BUILDINGS 5 & 6 RENOVATIONS
San Mateo County Community College District

CAÑADA COLLEGE
4200 Farm Hill Boulevard
Redwood City, CA 94061

ELEVATOR ENLARGED PLANS, SECTIONS AND DETAILS

8 TYP. INTERIOR ELEVATOR ENLARGED PLANS 1/4" = 1'-0"

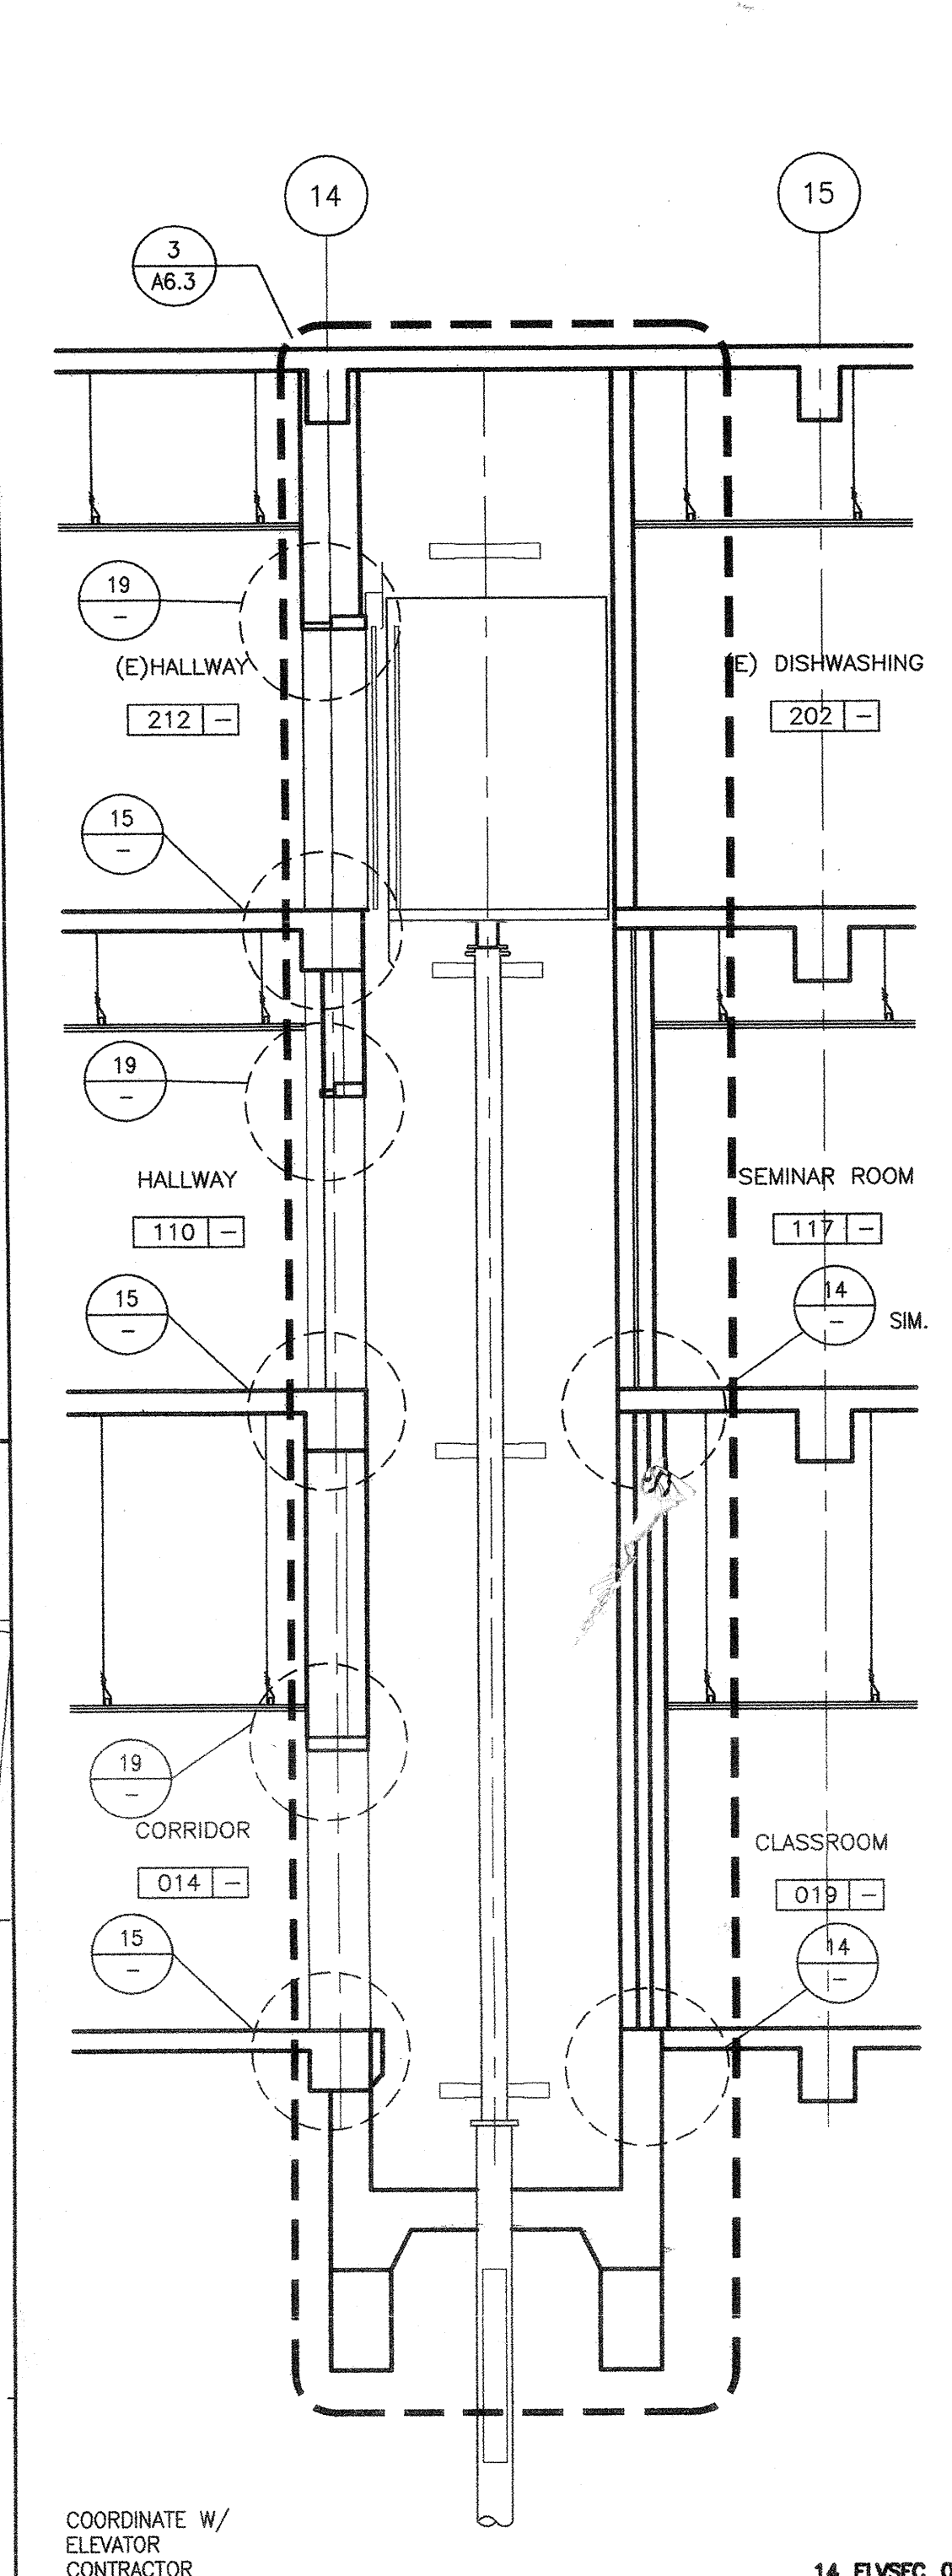
RFI 140 See opposite #1-8
Interior Elevator shaft
